# UNITED STATES PATENT AND TRADEMARK OFFICE

APPLICATION NO.	FILING DATE	FIRST NAMED INVENTOR	ATTORNEY DOCKET NO.	CONFIRMATION NO.
10/827,335	04/20/2004	Yoshihiro Mizutani	252085US3	2921
22850	7590	05/03/2005	EXAMINER	
OBLON, SPIVAK, MCCLELLAND, MAIER & NEUSTADT, P.C. 1940 DUKE STREET ALEXANDRIA, VA 22314				NGUYEN, GEORGE BINH MINH
ART UNIT		PAPER NUMBER		
		3723

<b>Office Action Summary</b>	<b>Application No.</b>	<b>Applicant(s)</b>	
	10/827,335	MIZUTANI ET AL.	
	<b>Examiner</b> George Nguyen	<b>Art Unit</b> 3723

JPP'56-9166(4)

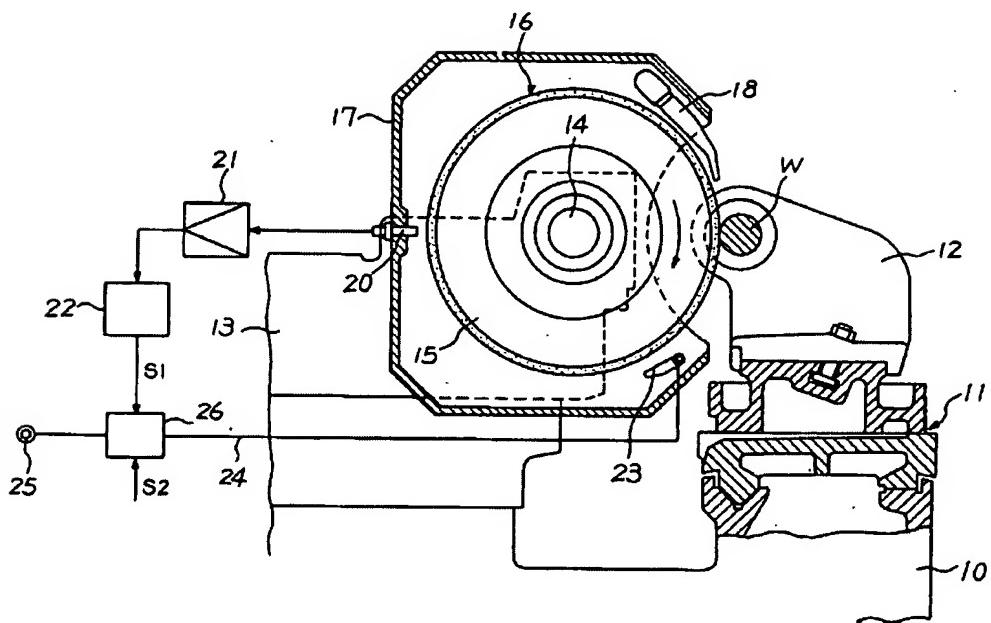
2. Claims 6, 8, 9, 10, 16, 17, 18, 19, and 20 are rejected under 35 U.S.C. 102(b) as being anticipated by Japanese Patent Publication'56-9166.

With reference to Figure 2, JPP'56-9166 discloses the claimed invention. It is noted that the limitations following the word "for" set forth in the claims have been considered , but not given any patentable weight because of its intended use. Please see MPEP 2114.

**Fig.2.**

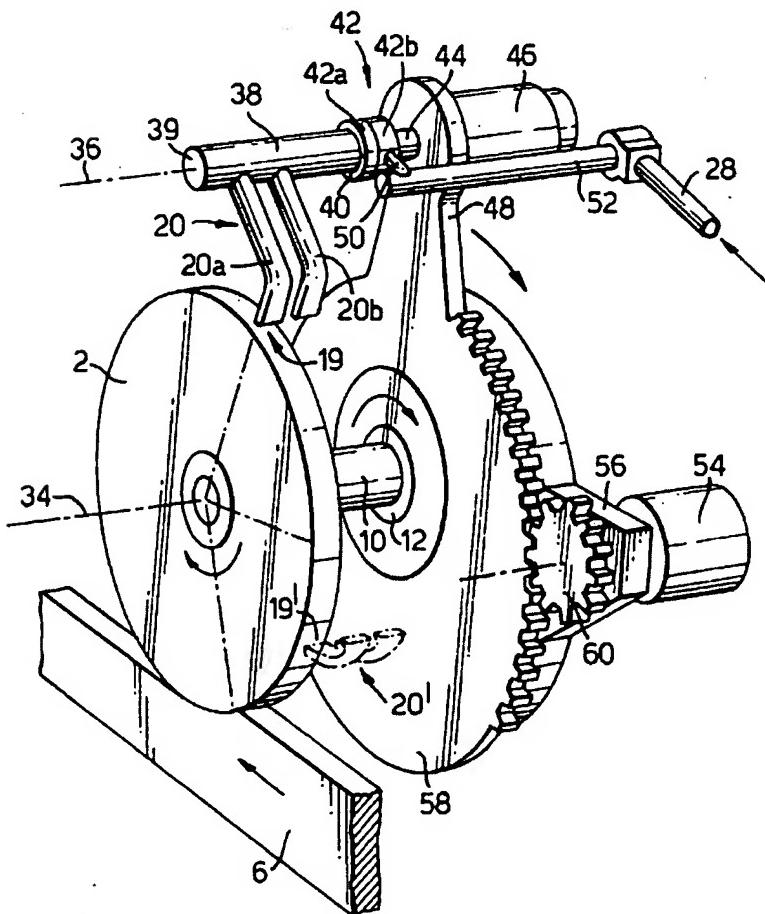
With reference to Figure 2, col. 3, lines 11-35, Hill discloses a cooling nozzle 20 having a straight portion between a tip opening and a curve portion. The straight portion includes a rectangular cross section. The rectangular cross-section is required to provide a jet 18 of coolant wide enough to cover the entire width of the grinding wheel 2.

Thus, it would have been obvious to one having ordinary skill in the art at the time the invention was made to have substituted the tapered nozzle of JPP'9166 with a straight nozzle as taught by Hill in order to direct a jet 18 of coolant in the shape of a sheet or fan at the periphery of the wheel to obtain substantially even distribution of coolant across the width of the wheel (col. 3, lines 23-25).
